ADDENDUM NO. 06
February 1, 2022

To Drawings and Specifications dated December 17, 2021

CLINE ELEMENTARY SCHOOL CAMPUS REPLACEMENT
FOR FRIENDSWOOD I.S.D.

Prepared by: PBK
11 Greenway Plaza, 22nd Floor
Houston, TX 77046-1104
PBK Project No: 20380

01 WALL SECTION AT SERVICE YARD
1" = 1'-0"

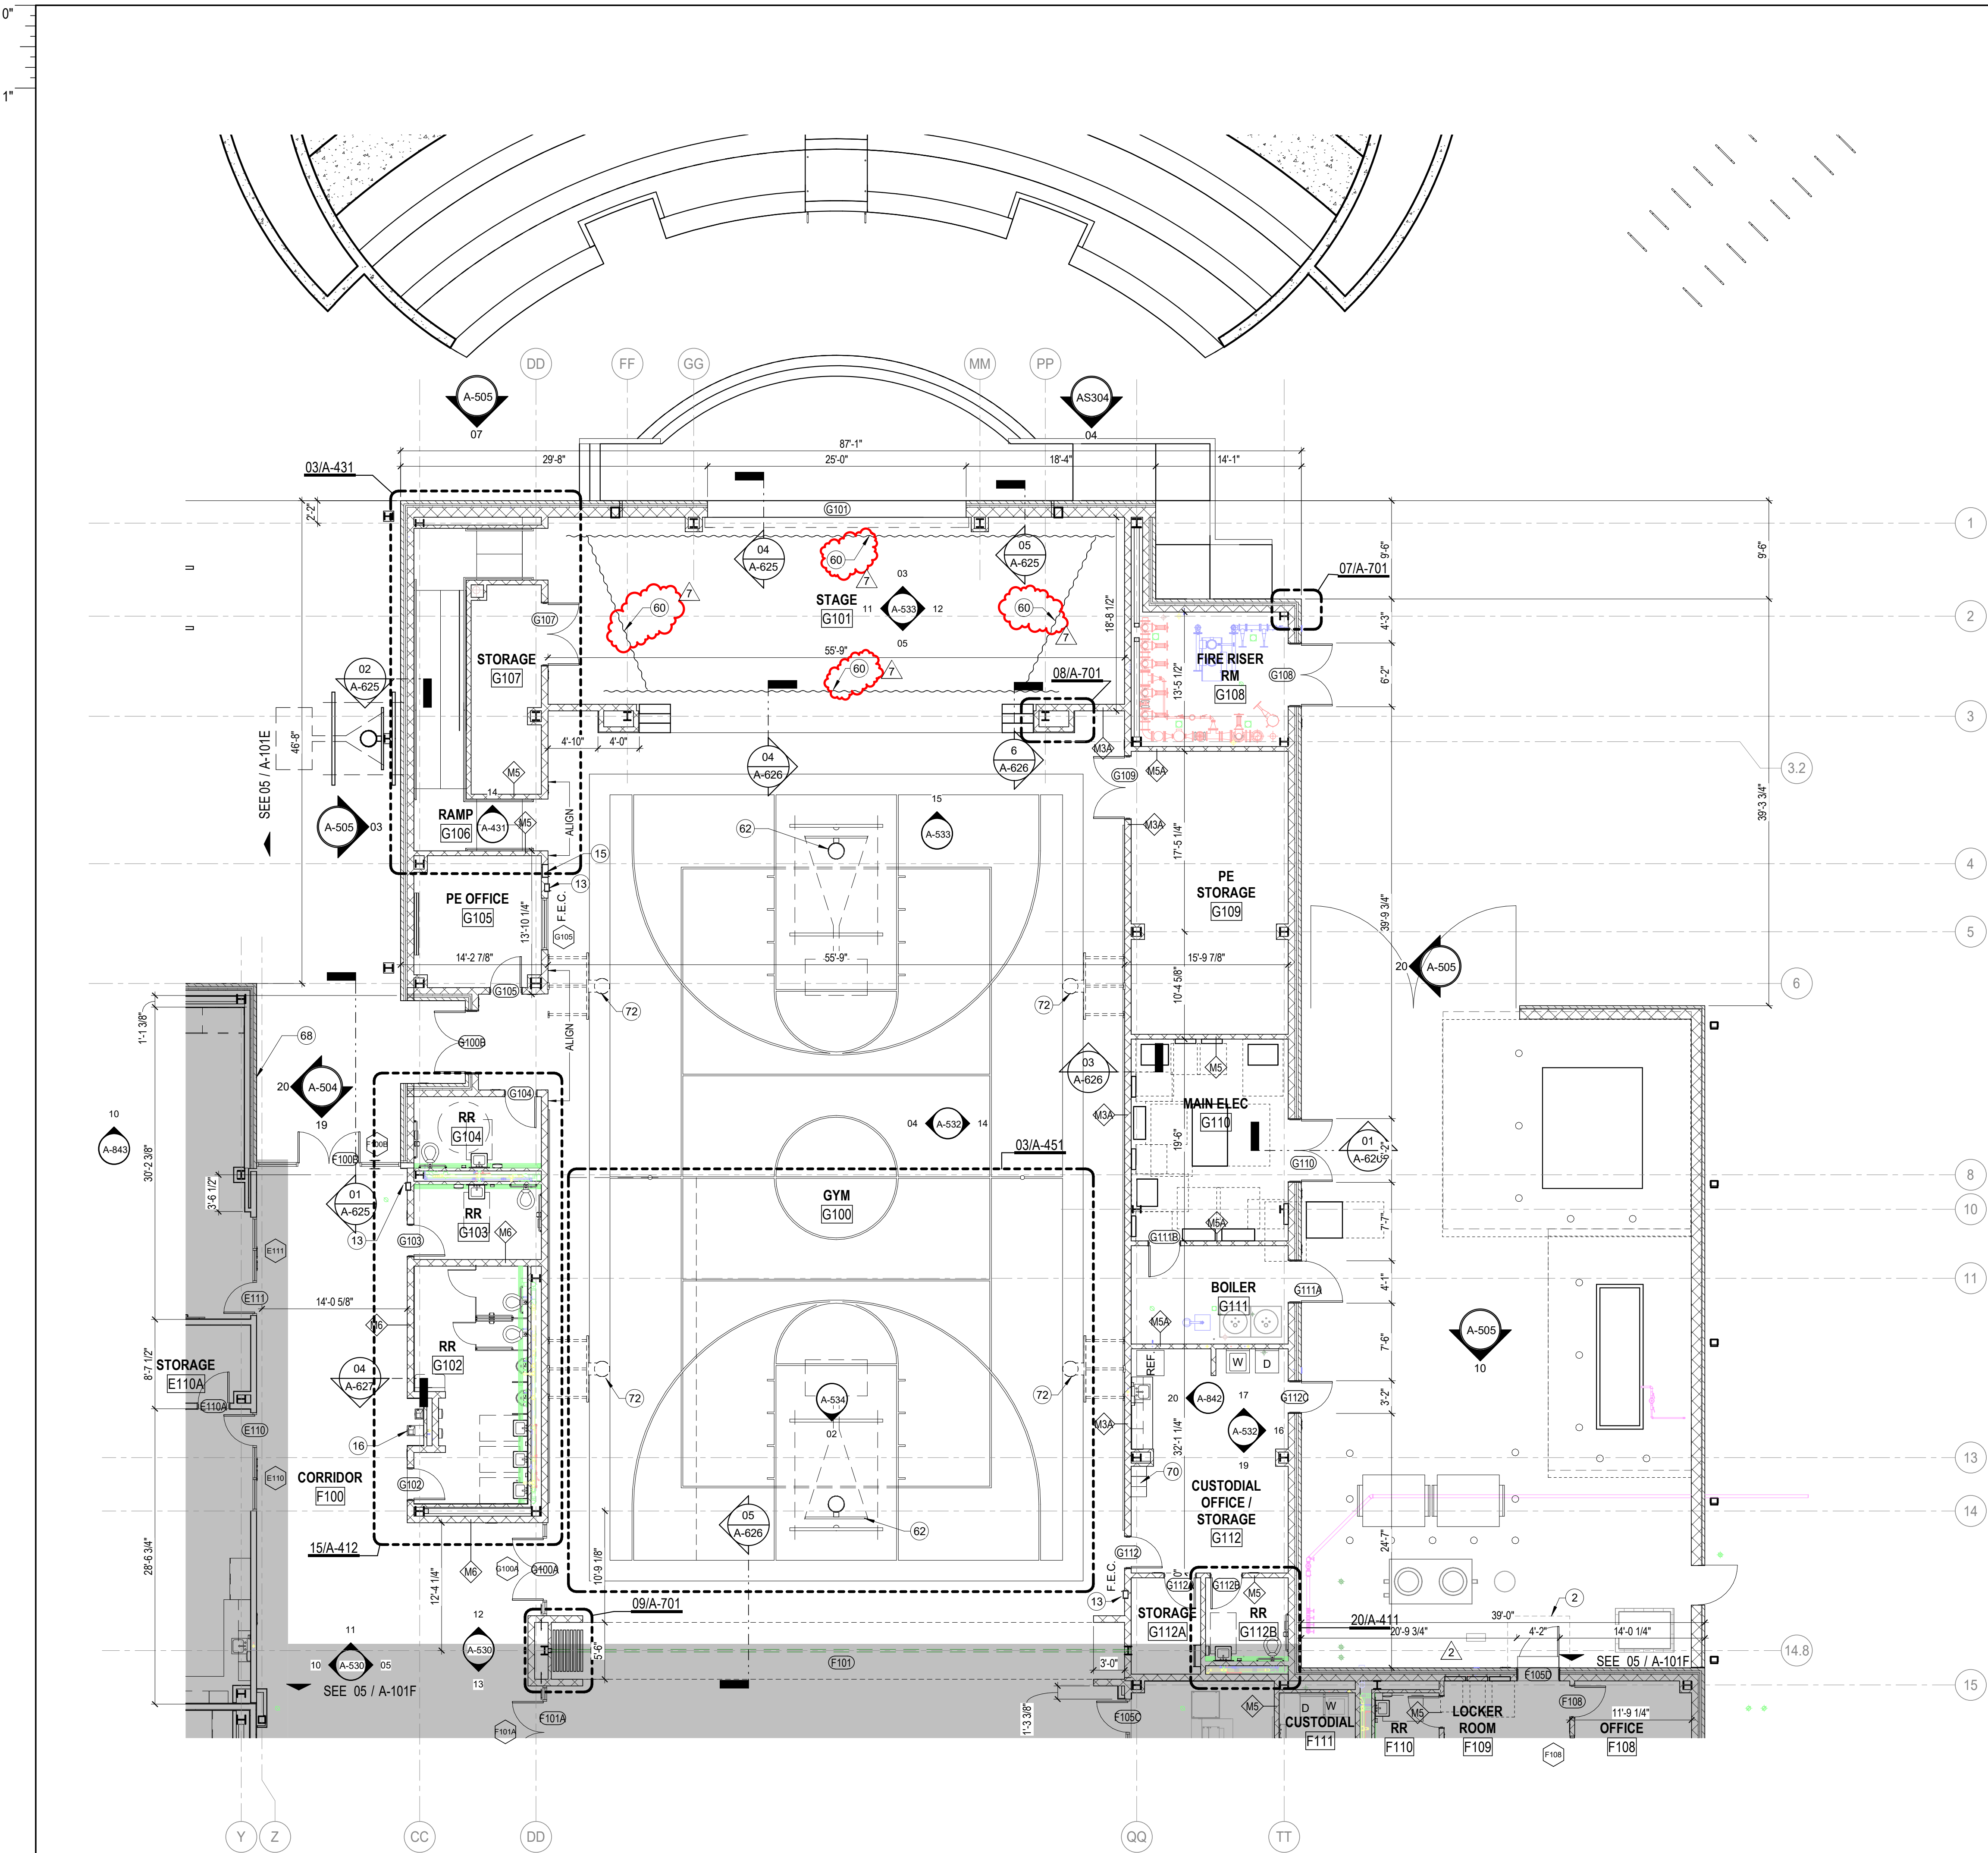
1. Revised wall section 01/AS303.

1ST LEVEL - FLOOR
PLAN - AREA G

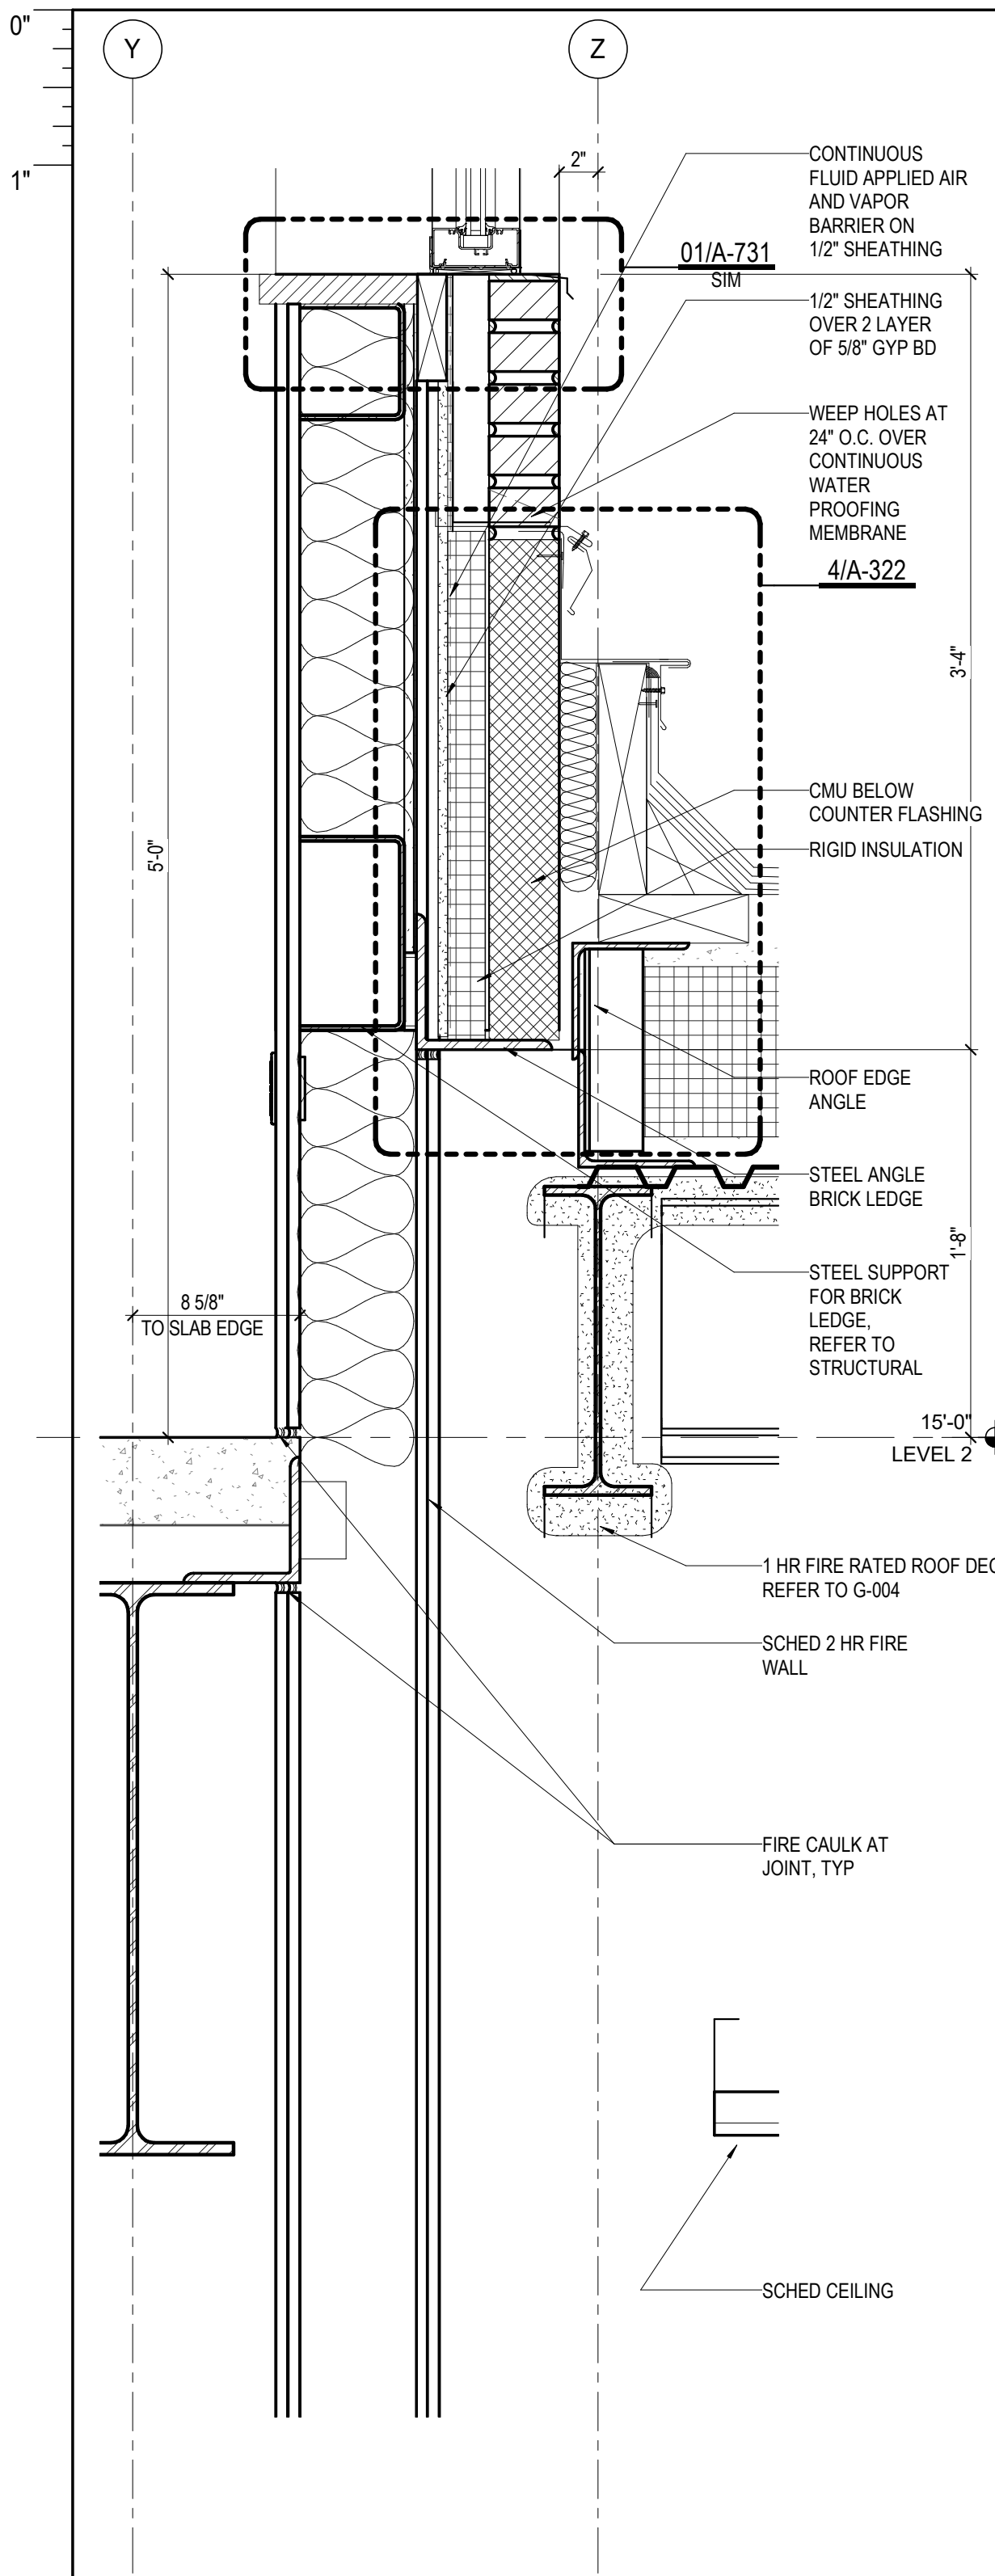
1. Added keynote 60.

19 SECTION DETAIL @ HIGH ROOF
1 1/2" = 1'-0"

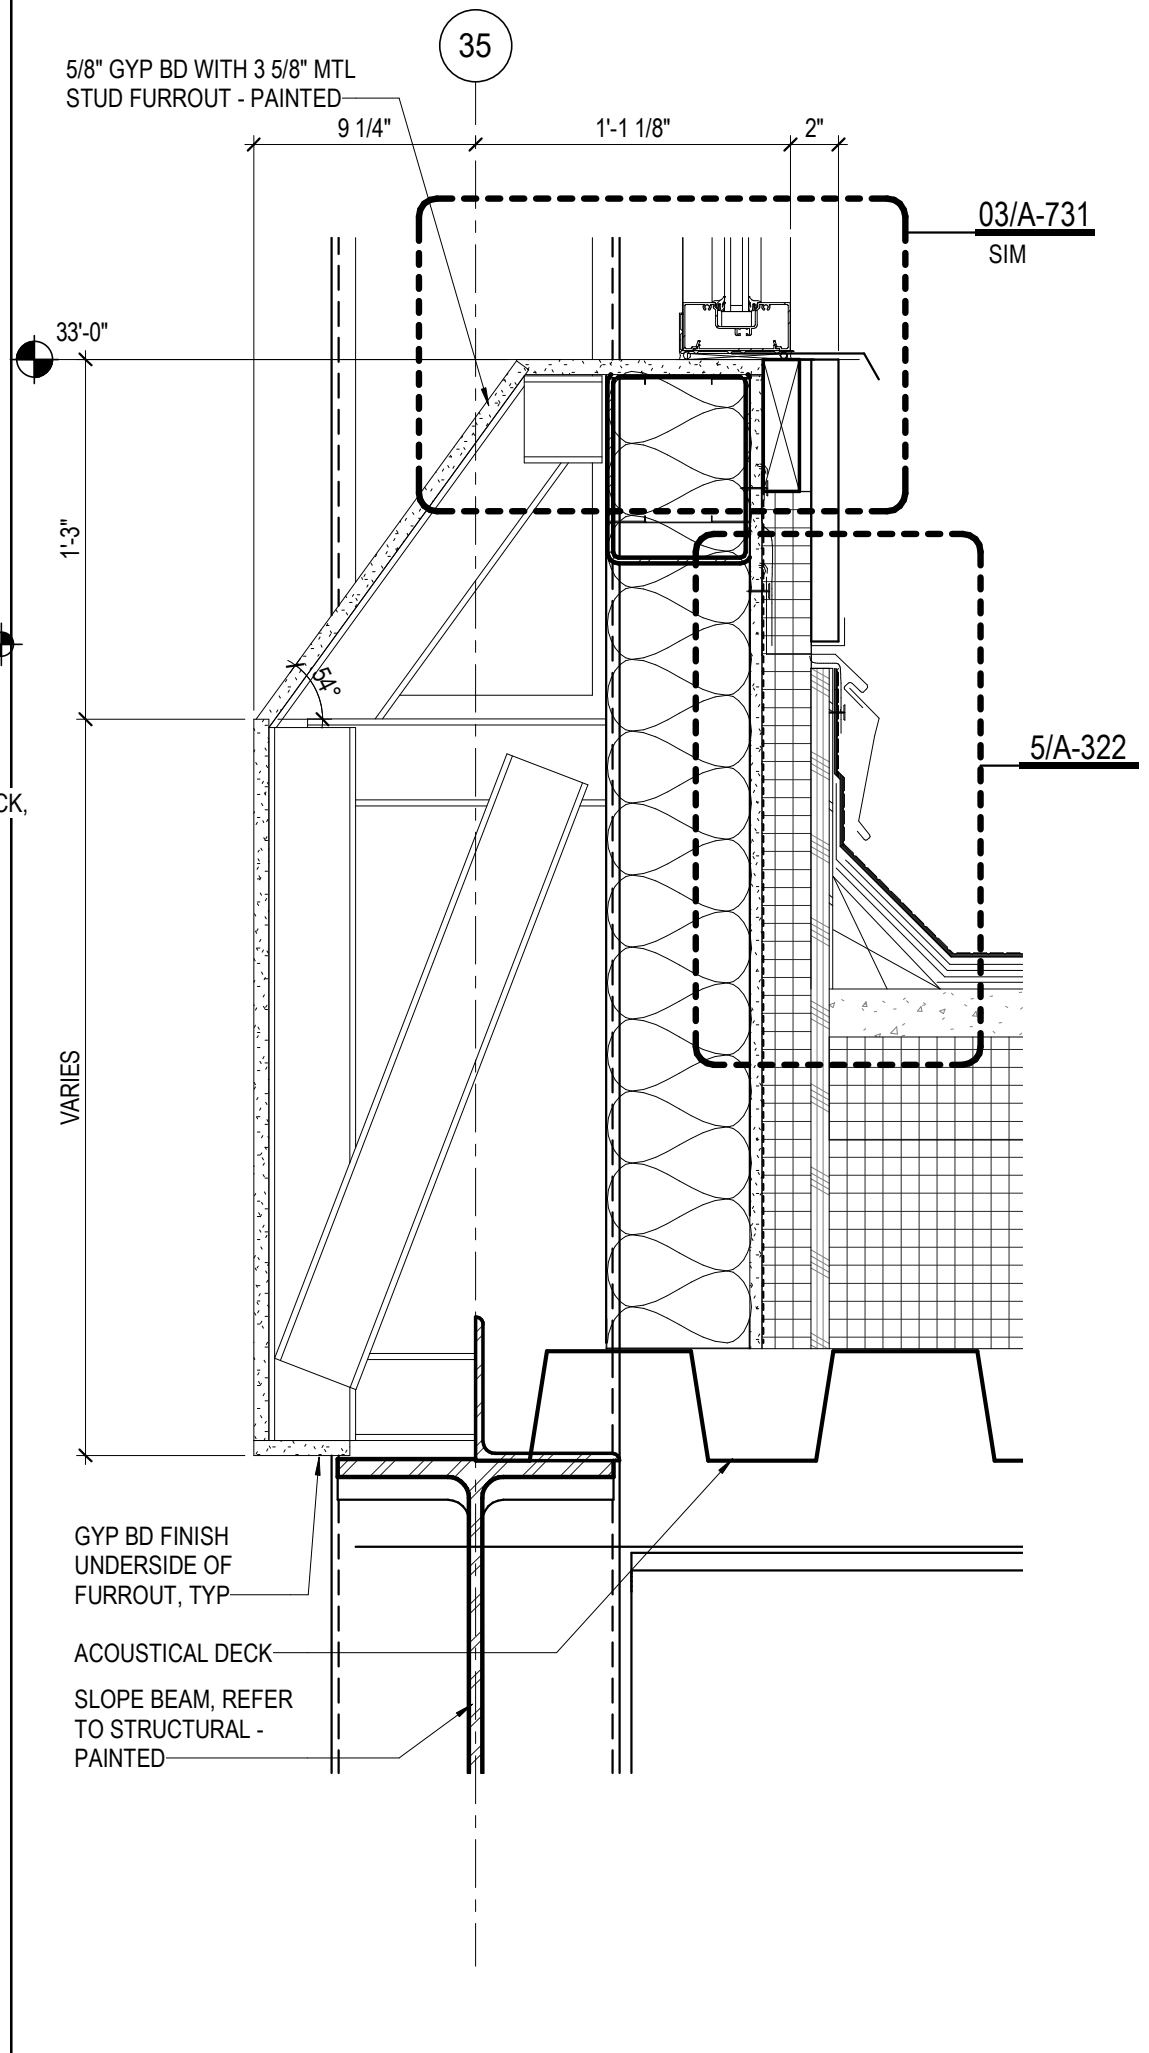
1. Clarified dimensions on masonry ledge.
2. Added Air damp on 19/A-721.
